Access Compliance Report

Public Rights-of-Way

(Pedestrian Signals)

Intersection ID: N/A	Main Street:	Cross Street: N/A	Location: N/A
ADA ID: 055D184A6CC9	Signal Type: One Push Button-Non APS	Overall Compliance: No	Severity Score: BTN 1: N/A BTN 2: N/A No BTN: N/A
Codes/Mitigation Info/Possible Solution		Field Measurements/Component Compliance

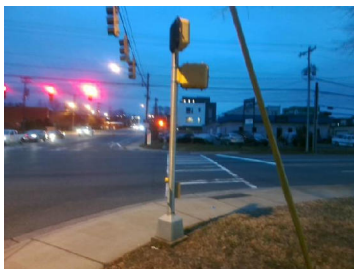
PROW/ADA: TMUTCD 4e.08, R404.3, R406.2

Yes	B 1 Clear Xing Direction?	ClearlyMarked	N/A	B 2 Clear Xing Direction?	N/A
	B 1 Crossing Direction	To SE		B 2 Crossing Direction	N/A
Yes	B 1 DistanceTo XWalk (in)	0.0	N/A	B 2 DistanceTo XWalk (in)	N/A
No	B 1 DistanceTo Curb (in)	85.0	N/A	B 2 DistanceTo Curb (in)	N/A
Yes	B 1 Diameter (in)	2.0	N/A	B 2 Diameter (in)	N/A

Possible Solutions: Replace Signal Push Button With APS Button on New Post. Remove & Relocate Sign.
